City of Portland, Maine – Building or Use Permit Application 339 Congress Street, 04101, Tel: (207) 874-8703, FAX: 874-8716

Location of Construction: 67 Verrill St (Lot 7)		Owner: Tim & Rene Darling		Phone:		Permit No: 941331
Owner Address:		Leasee/Buyer's Name:		Business Name:		
Contractor Name: Robert Ryder Building Contractors		Address: P.O. Box 642 Springvale, ME		Phone: 04083 247-3918		<div style="border: 2px solid black; padding: 5px; text-align: center;"> PERMIT ISSUED Permit Issued: <div style="border: 1px solid black; padding: 5px; margin: 5px 0;"> DEC 13 1994 </div> CITY OF PORTLAND </div> Zone: CBL: 299-A-A-020-022
Past Use: Vacant land		Proposed Use: 1-fam dwelling		COST OF WORK: \$ 70,000 FIRE DEPT. <input type="checkbox"/> Approved <input type="checkbox"/> Denied INSPECTION: Use Group: R-3 Type: 5B Signature: [Signature]		
Proposed Project Description: Construct single family dwelling as per plans		PEDESTRIAN ACTIVITIES DISTRICT (P.U.D.) Action: Approved <input type="checkbox"/> Approved with Conditions: <input type="checkbox"/> Denied <input type="checkbox"/> Signature: _____ Date: _____		Zoning Approval: Special Zone or Reviews: <input type="checkbox"/> Shoreland <

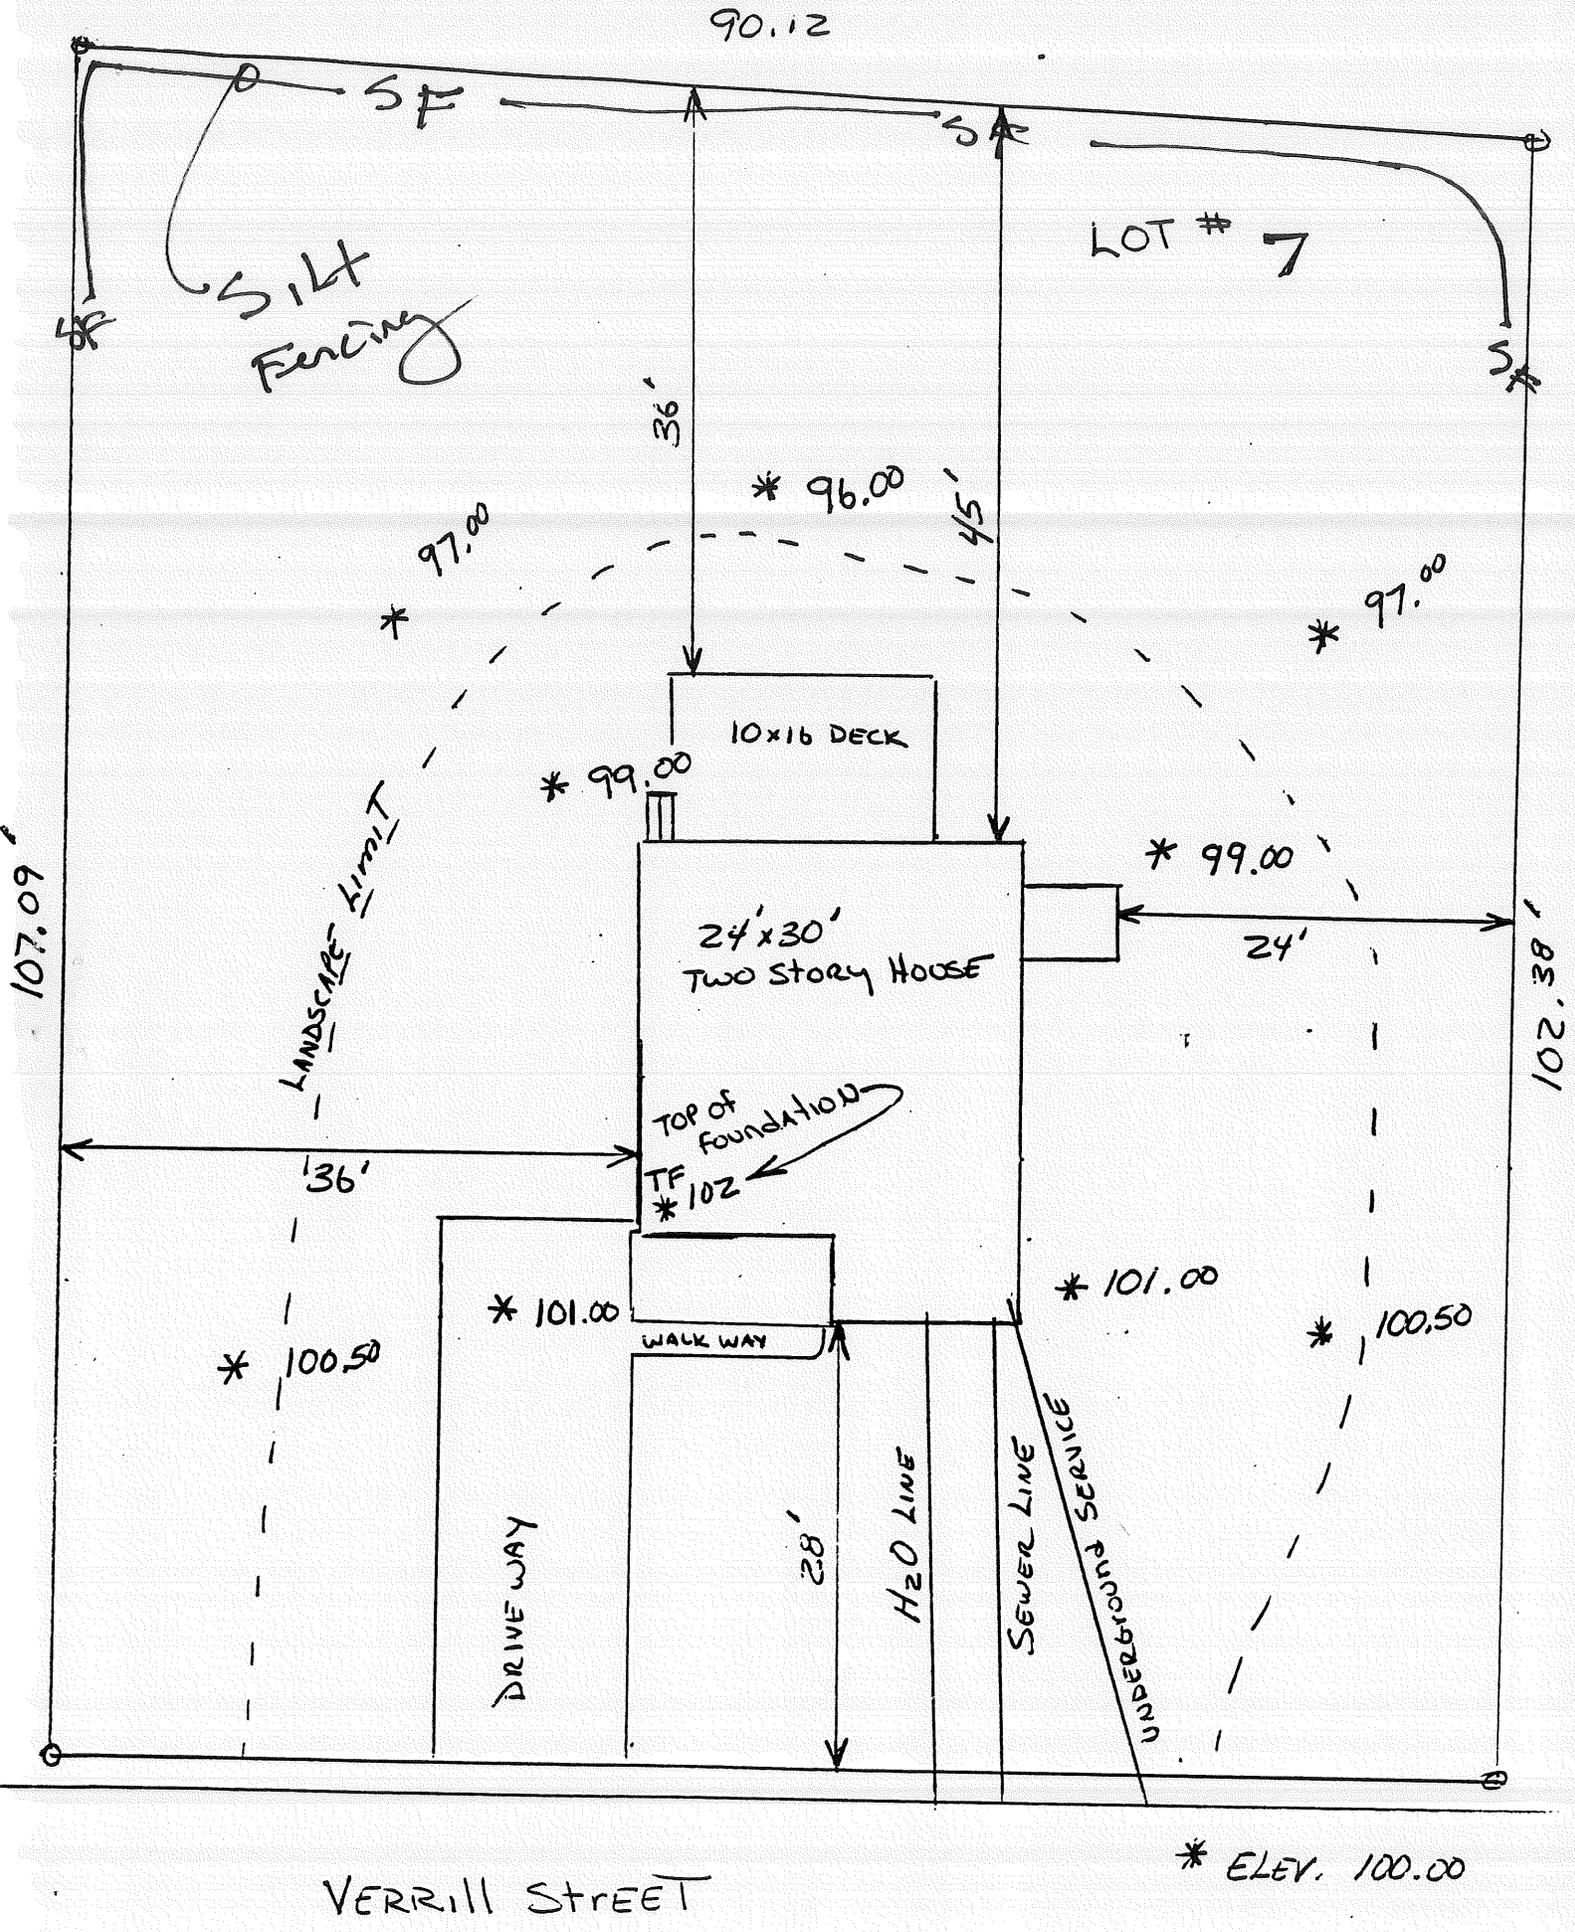
Proposed NEW LOCATION

ORIGINAL LOCATION of Basement Entry

Same req - No less than 14' side yd. required (30' shown)

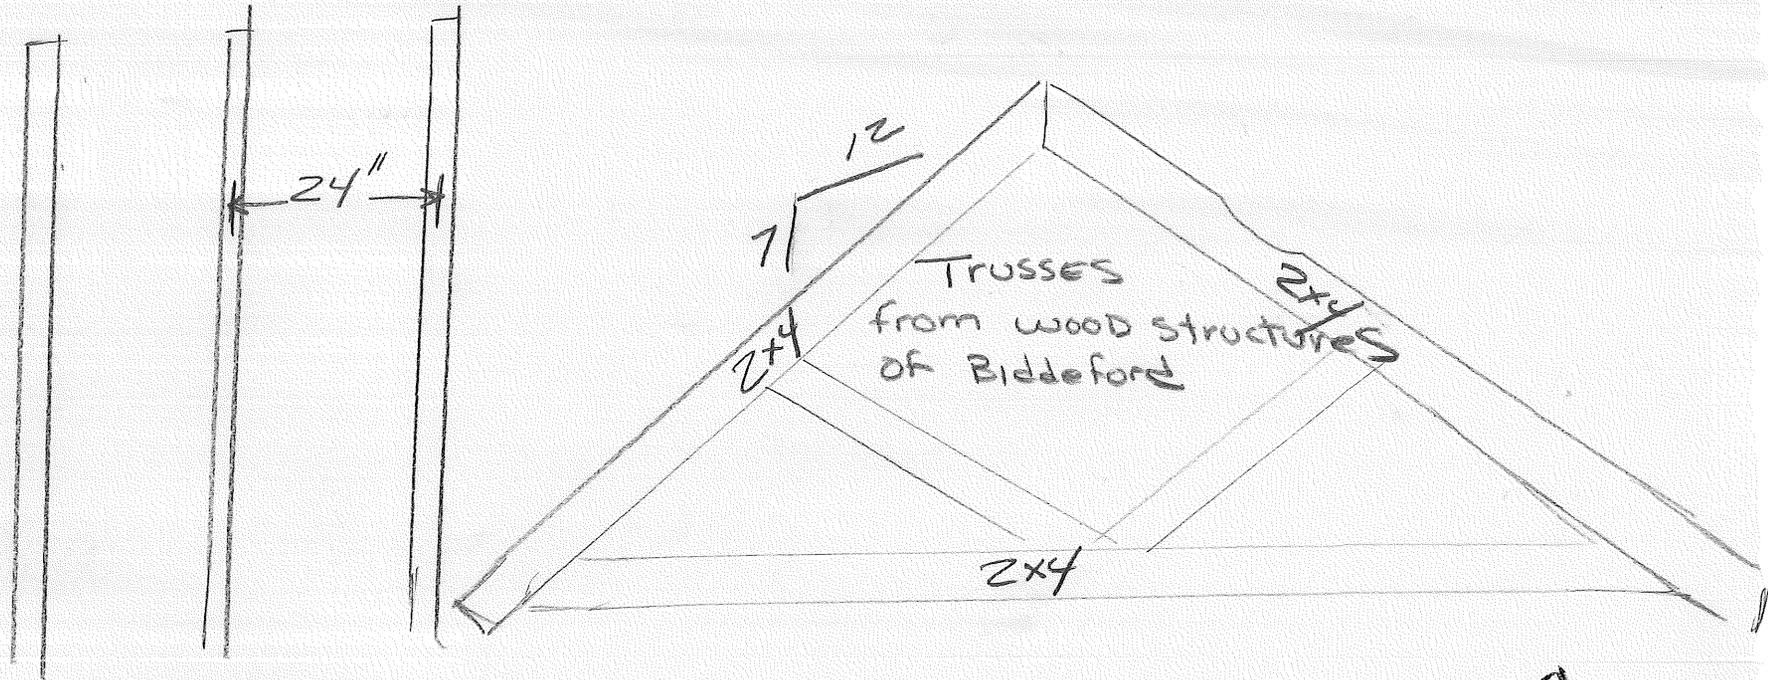
4. Siltation fencing shall be repaired at the limit of construction at the rear of the lot as shown on the plans reviewed by Owens McCullough dated 12/9/94. Siltation fence should be properly toed and secured by either a date when ground surface becomes unfrozen enough to install fencing or a date no later than April 1, 1995. Siltation fence may be removed once areas disturbed by construction have become 80% revegetated.

Silt Fencing

Install silt fencing at location shown on attached plan prior to construction

Truss roof system

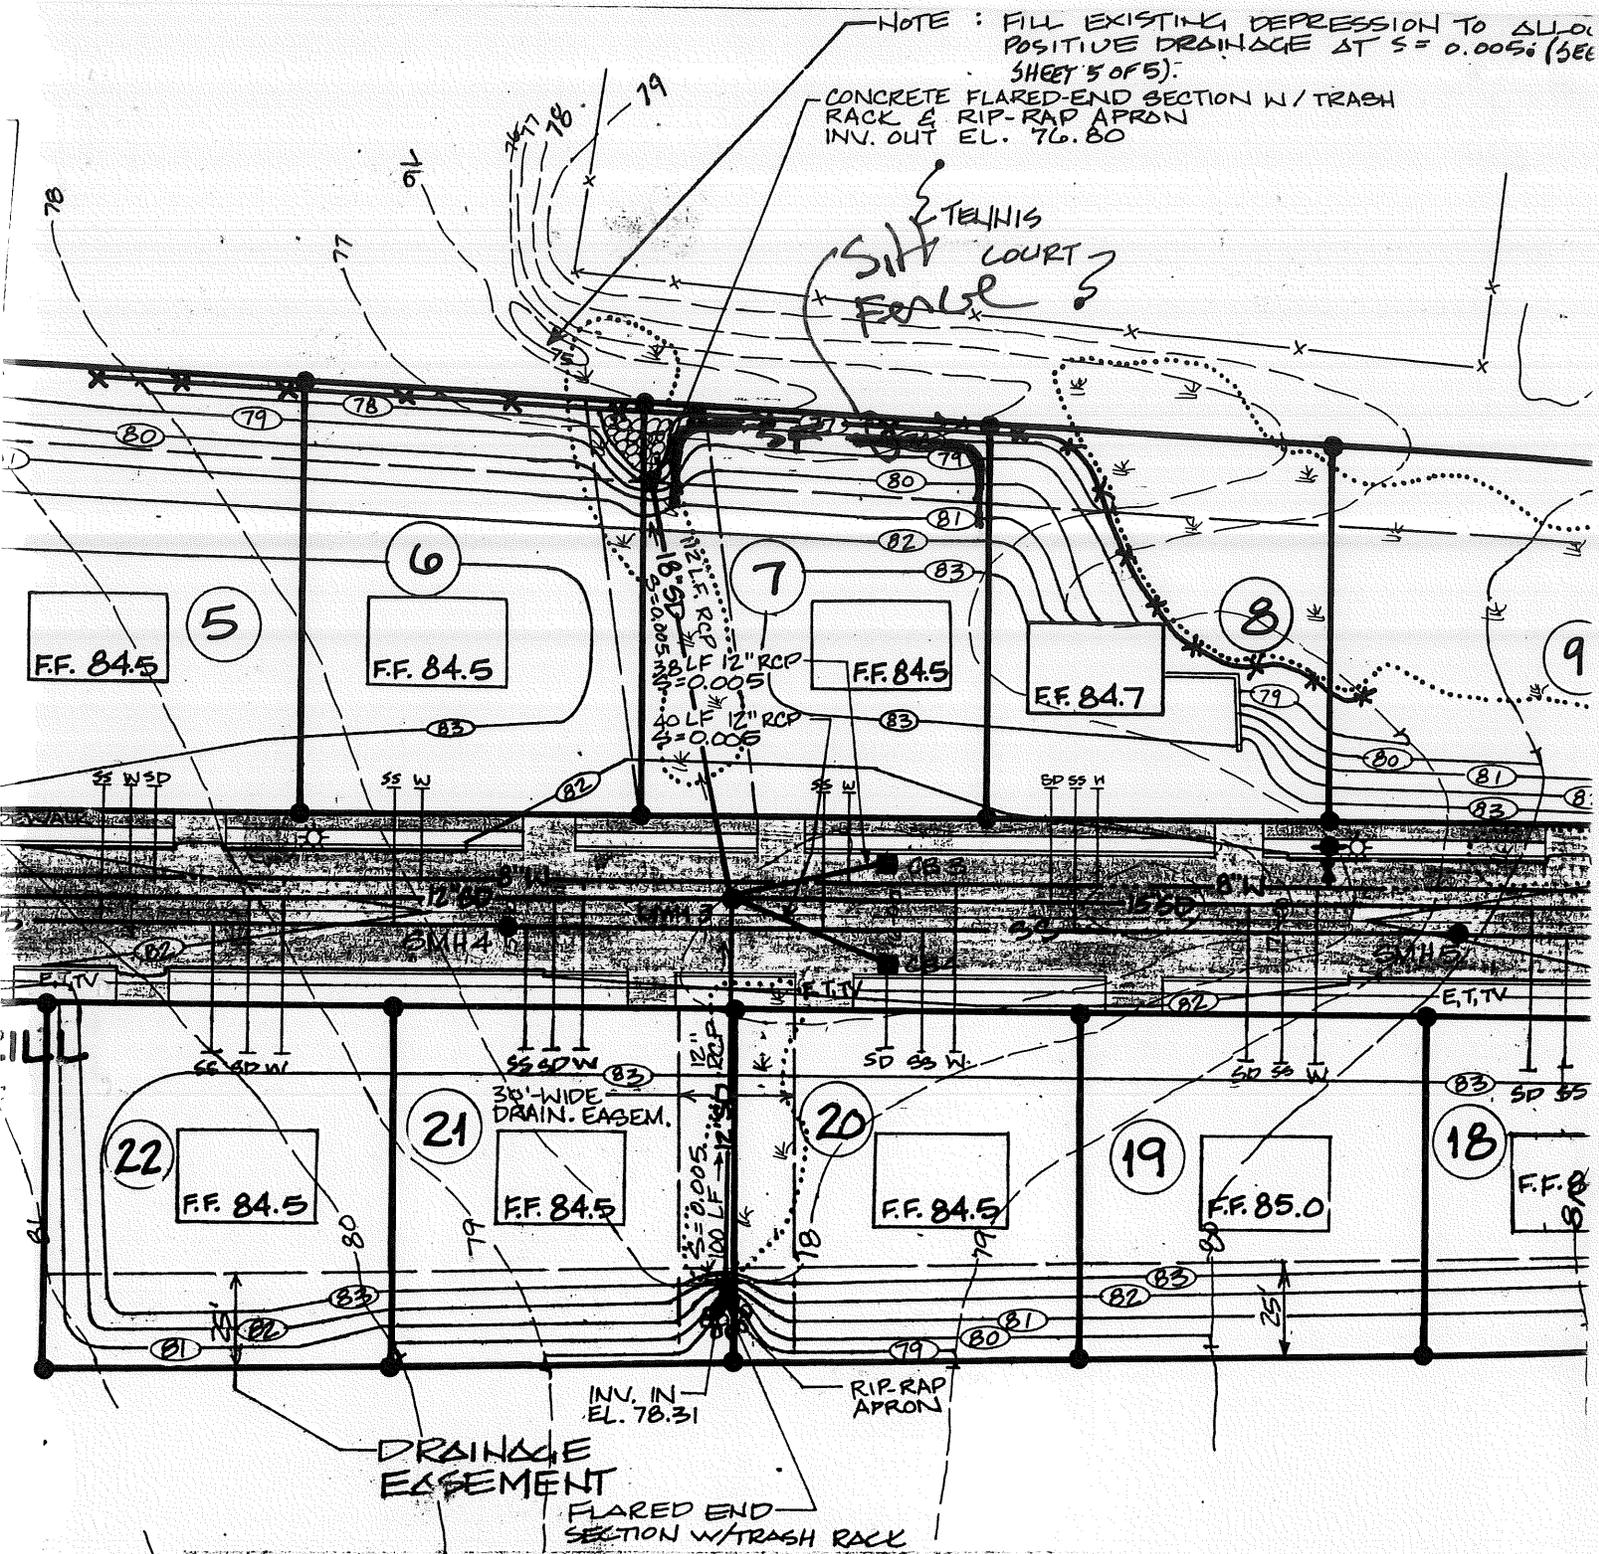
1-26-95 - 2x8 Rafter (2x4 Trusses @ 2'oc) (need Amendment)

To change roof structure - to use trusses.

This proposed change in the roof design to use wood trusses, must be installed as per the design specification.
